# ICN ad hoc report

Tom Palkert

*1/27/2012*

# Mated compliance board ICN measurements

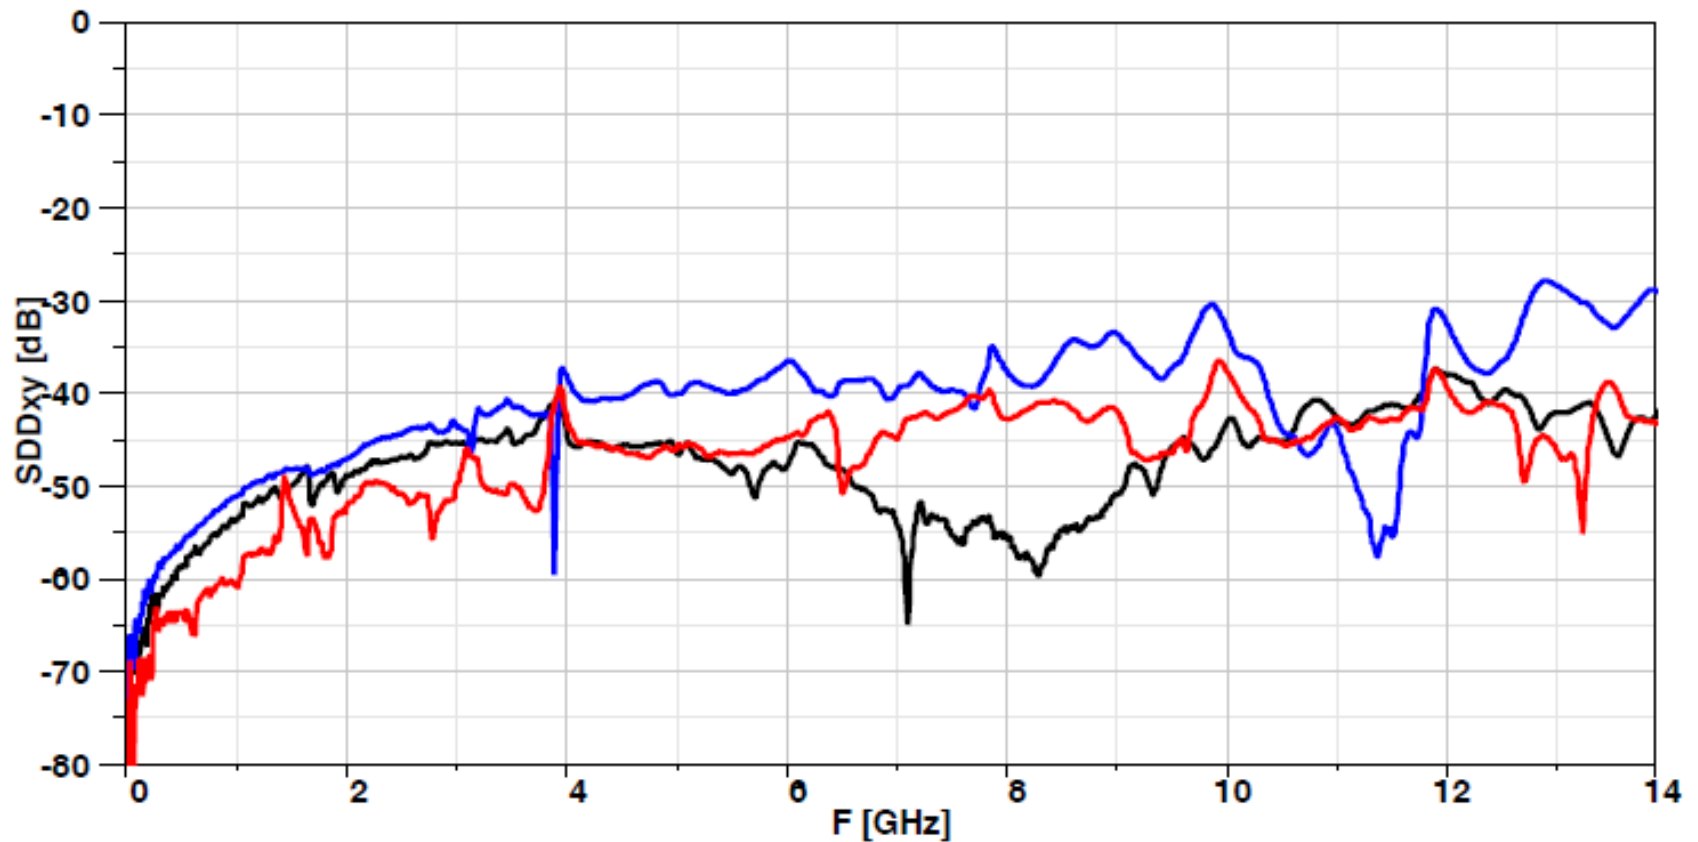
ICN settings: 10.3125Gbps 0.6V amplitude  
The ICN calculates to: 5.6mV

25ps 20-80 risetime

# Cable Assembly ICN (Includes cable assembly test fixtures)

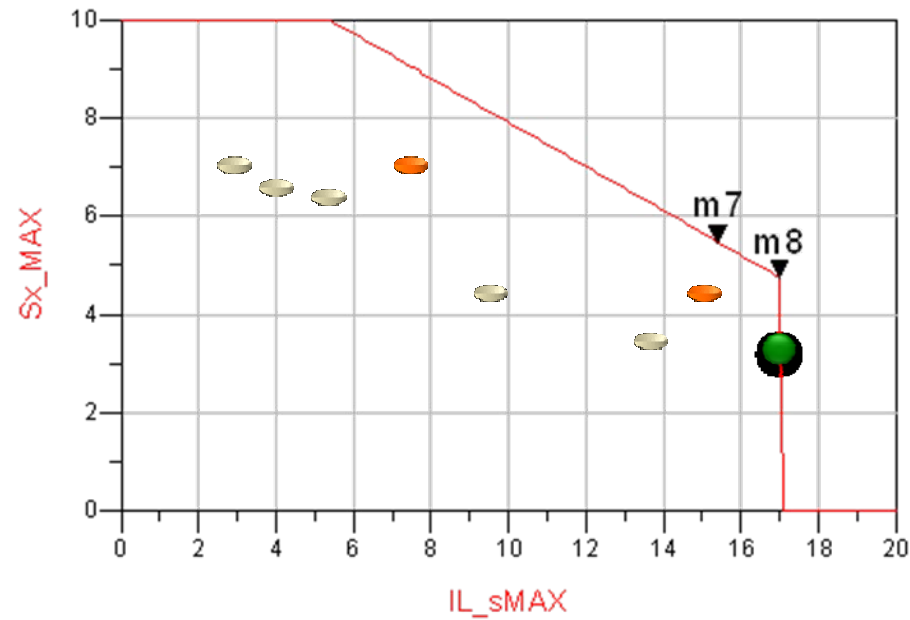
m7  
 indep(m7)=15.400  
 plot\_vs(Sx\_MAX, IL\_sMAX)=5.470

85.10.7, equation 85-  
 33 – IEEE Std  
 802.3ba-2010

m8  
 indep(m8)=17.000  
 plot\_vs(Sx\_MAX, IL\_sMAX)=4.750

Snx	Sfx	Sx
2.699	1.874	3.286
